From: Laura Gibbons <Laura.Gibbons@arun.gov.uk>
Sent: 04 May 2021 08:58
To: Raymond Cole <Raymond.Cole@arun.gov.uk>
Cc: Claire Potts <Claire.Potts@arun.gov.uk>; Planning.Responses
<Planning.Responses@arun.gov.uk>
Subject: RE: Ford Airfield (Ref F/4/20/OUT) - Drainage Engineer Responses

Thank you for your latest comments regarding the surface water drainage strategy for the Ford Airfield development (Ref F/4/20/OUT) following the additional information and updated design provided in JNP Group Drainage Strategy Technical Note Ref C85228-JNP-XX-XX-RP-C-1000-P2 dated 10 February 2021.

2.1 JNP Drawing C85228-SK130 summarises the direction the ground falls across the site. For the avoidance of doubt the natural ground surface profile in the north of the site falls to the northeast. In the south of the site the ground surface generally falls to the west/ south west.

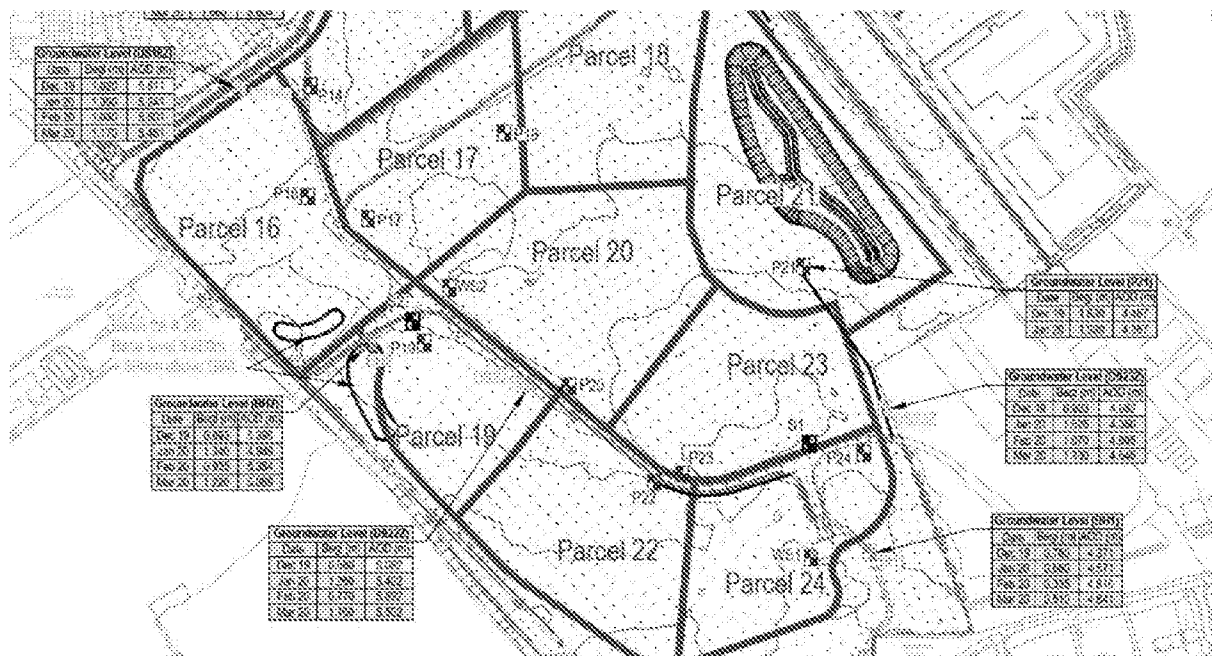
The proposals for attenuation and pumping of this area of the development do not comply with adopted WSCC policy for the management of surface water, specifically policy 3- mimic natural flows and drainage flow paths. No evidence has been submitted to show why compliance with this policy requirement cannot be achieved. The natural catchment appears to indicate this area should drain toward the watercourses under Yapton Road. We do not support drainage proposals which do not follow existing catchments or look to utilise pumping.

2.2 JNP Drawing C85228-SK120 reviews the ground surface across the south of the site in more detail. It highlights that there are numerous depressions across the south of the site which collect surface water runoff, reducing the flow westwards

2.3 Groundwater monitoring, at relatively shallow depths, proves that groundwater flows northwards beneath the site.

2.4 The impact of the runways, access roads and existing surface water sewerage systems onsite which historically (for over 70 years) have captured surface water runoff and discharged it to the River Arun in the east should not be ignored.

2.5 The proposed drainage design strategy does discharge the westerly parts of the site to the watercourses under Yapton Road. The design mimics the current surface water runoff regime at the site.

2.6 The groundwater in the west of the site is extremely shallow. With reference to the monitoring results below it was less than 1.0m below ground level over the winter. The attenuation basin was located to Parcel 21 where groundwater is circa 1.9m below existing ground level over the winter period. This provides a more robust design for the south of the development.

2.7 The watercourse under Yapton Road / Horsemere Green Lane has a bed level of 3.03m AOD and a recorded water level of 4.00m AOD. The ground level at the western boundary of the site, nearest to the watercourse is circa 4.8m AOD. Groundwater has been recorded onsite less than 0.5m below the ground surface. Using open channels and basins in the west of the site is not feasible due to the

risk of groundwater ingress. It is considered a pumping solution or significant ground raising would be required if the surface water runoff from all areas in the south of the development is directed to the Yapton Road watercourses.

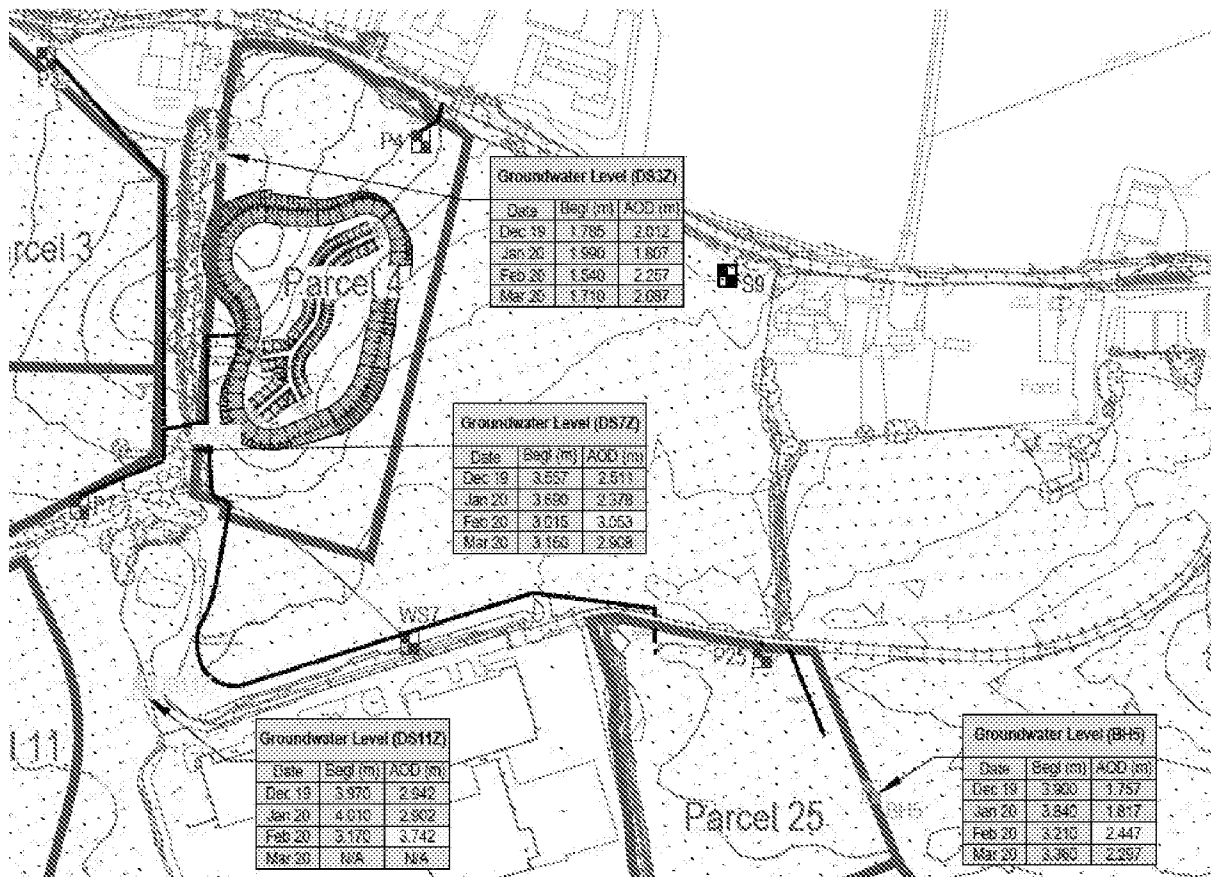
We note that the northern infiltration basin is proposed to have a base level of 2.45mAOD. There are two equidistant monitoring points from the proposed basin location, one of these recorded groundwater at 3.053m AOD. The proposed basin level therefore appears to be too low, without further evidence to the contrary. This will impact upon the upstream network, and may mean that a larger basin plan area is required. Groundwater monitoring at the location of proposed features will be required.

4.1 The groundwater monitoring of all wells across site show that groundwater flows northwards. In the north of the site the difference in water levels and the hydraulic gradient is significant. Water flows through the ground with the groundwater level deepening over short distances. The following extract from JNP Drawing C85228 D109E provided in the DSTN shows this.

4.2 Above ADC has highlighted the worst cast groundwater level in the monitoring well, to the south of the basin, is 3.050m AOD. The well to north recorded 2.257m AOD. The base of the basin is specified as 2.450m AOD. This diagram was included in Section 7.5 of the DSTN which advised “the proposed base level of 2.450m would reduce the risk of groundwater ingress into the basin based on the worst case winter results taken during a significantly wet period”.

4.3 Due to the flow of groundwater through the underlying strata it does not appear that groundwater will pond in the basin. The groundwater levels recorded during the wettest winter period show groundwater is not level and is not static.

4.4 Section 7.8 of the DSTN confirms that basin has a 670mm freeboard to the crest of basin. The nearest plot FFL is 600mm higher than the crest of the basin. If groundwater is present in the base of the basin there is significant additional attenuation capacity.

4.5 We do not recommend the base of the basin is raised as this will increase the level of the incoming sewer network and ground levels across the north of the site. This will impact on earthworks and increase the volume of imported fill. The proposed solution and base level of the basin is the more sustainable option.
